# FLYING HORSE NORTH FILING NO. 5 CONSTRUCTION DOCUMENTS

COVER & LEGEND  
COVER

PCD FILE NO.: SF2427

STREET PLAN & PROFILE  
 SANDBAGGER DRIVE

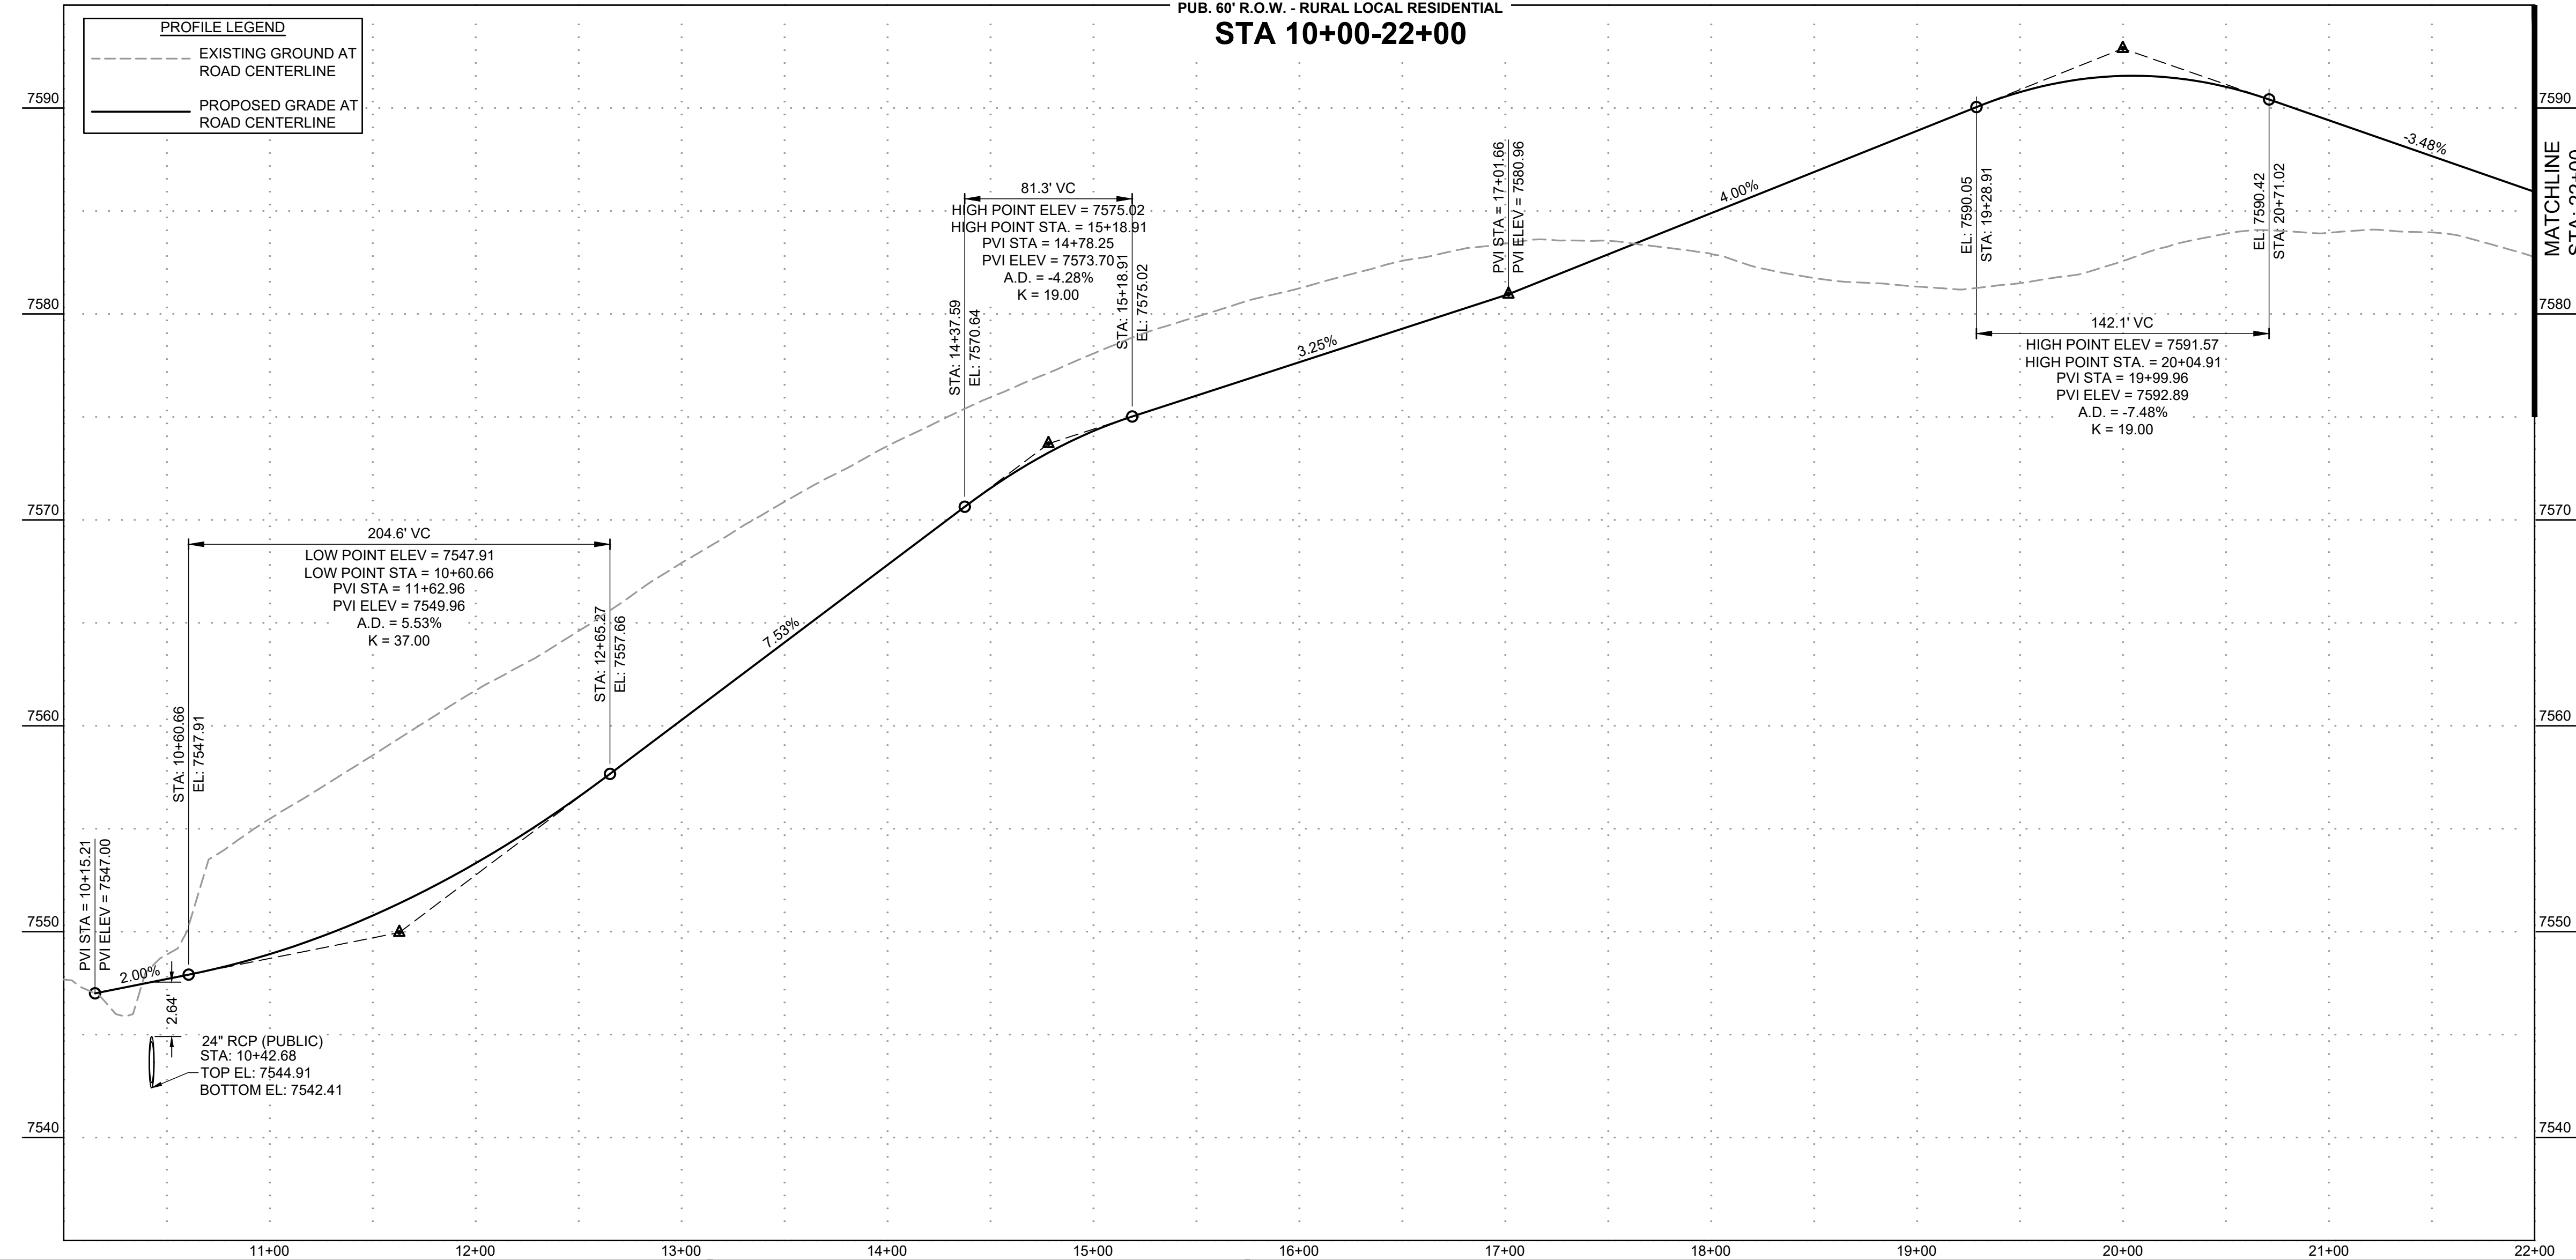
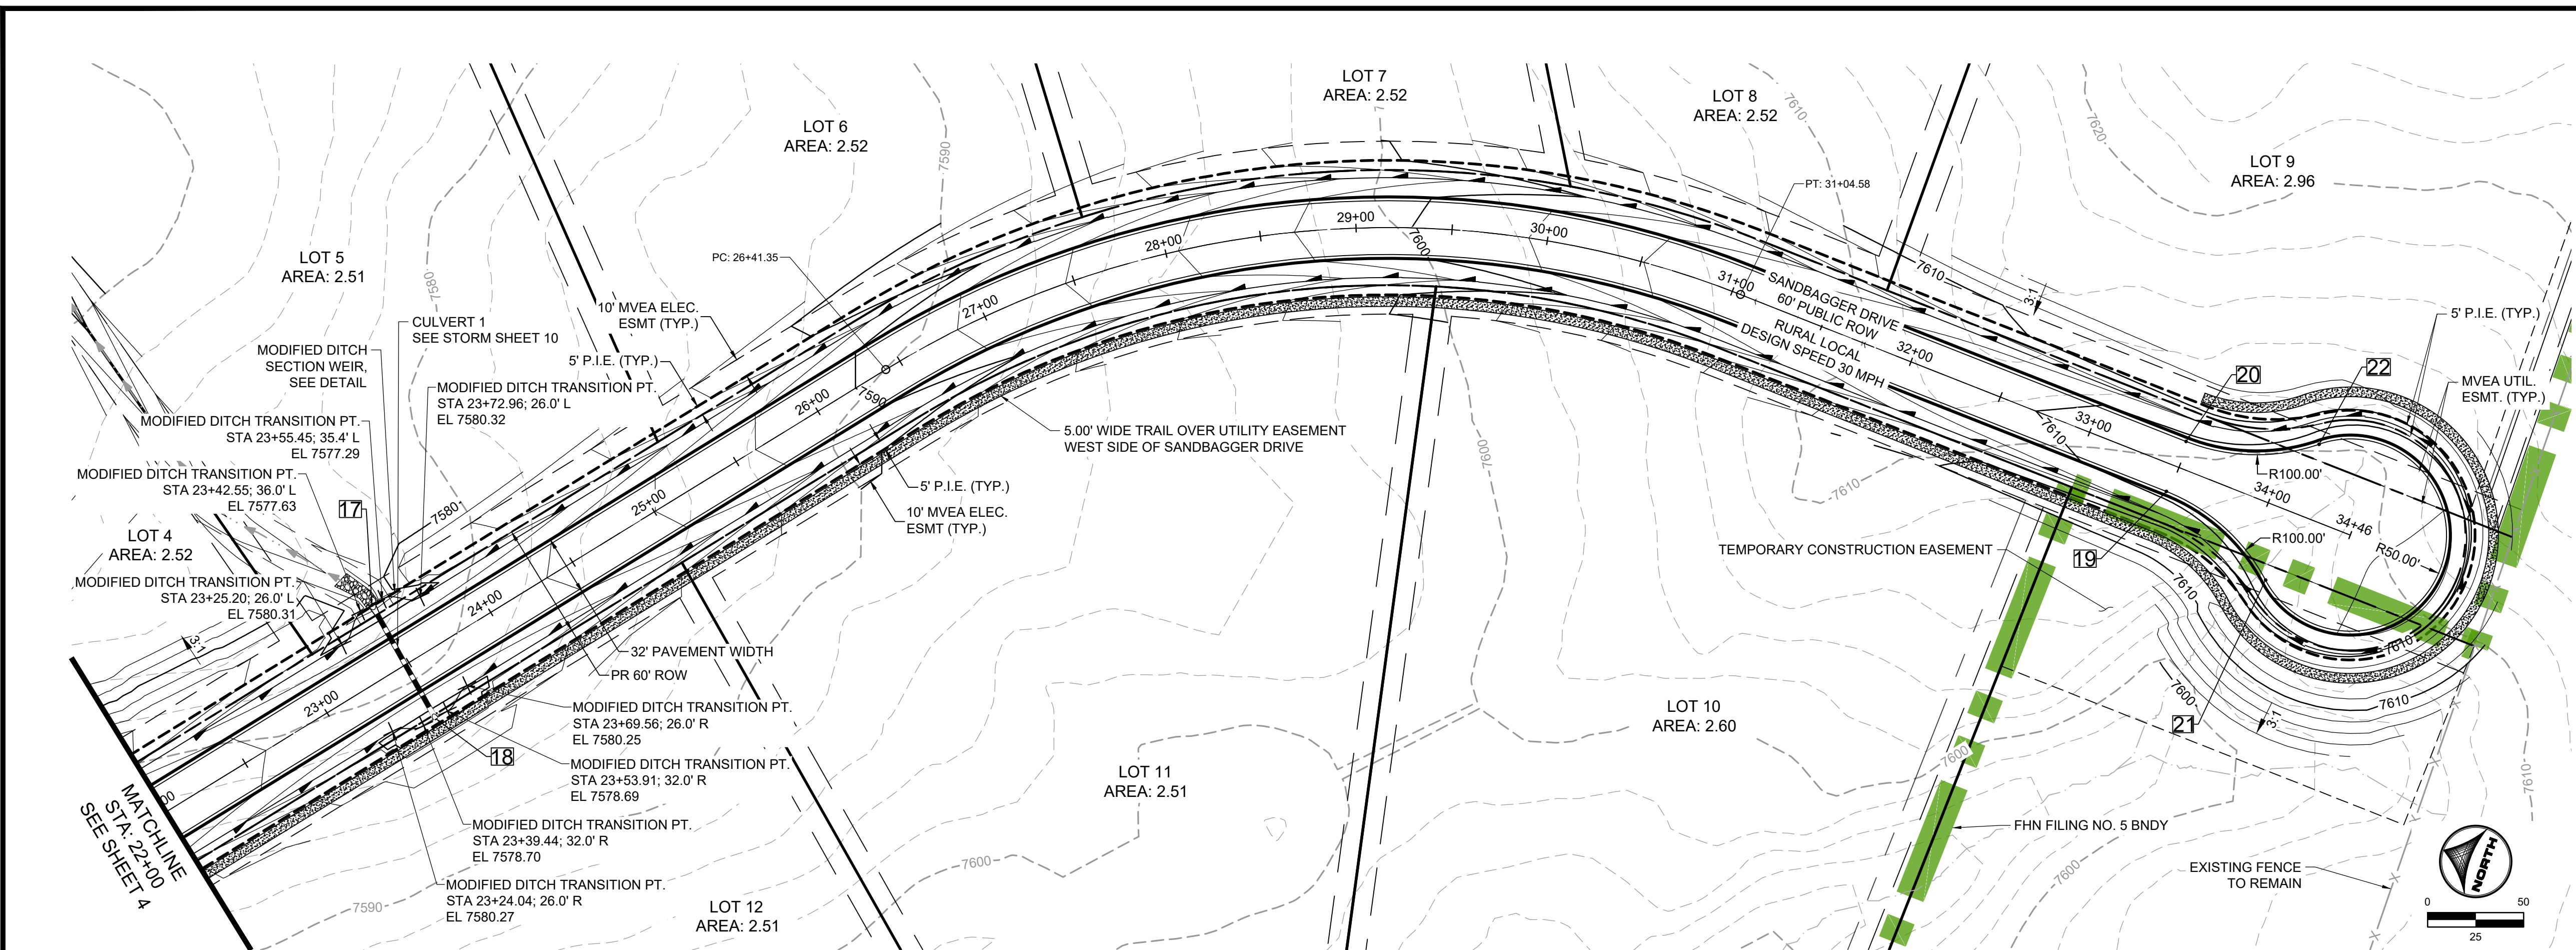
Update to match the new profile on cover sheet
